Filed: January 16, 2012
EB-2012-0365
Exhibit B
Tab 1
Schedule 3
Responses to Lori Bryenton
Interrogatories
Appendix A

Dufferin Wind Power Project
Lands Yet to be Secured Along 230 kV Line

MAP OF UNSECURED EASEMENTS

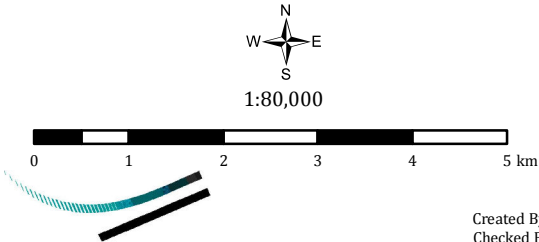
As per Exhibit B, Tab 1, Schedule 1, p. 4 of 7, item 11, the Applicant refers to private lands that are required for the Transmission Line, admitting that not all easements or leases have been acquired, referring to ‘a few minor exceptions’. We disagree with the term ‘minor’, as any gap in a transmission route will most certainly affect the ability to provide reliable electricity to consumers. We request proof that these private land owners have signed leases or easements, and maps showing the exact locations of these parcels.

A map showing the locations of parcels for which land rights have not yet been secured is provided in Appendix A.
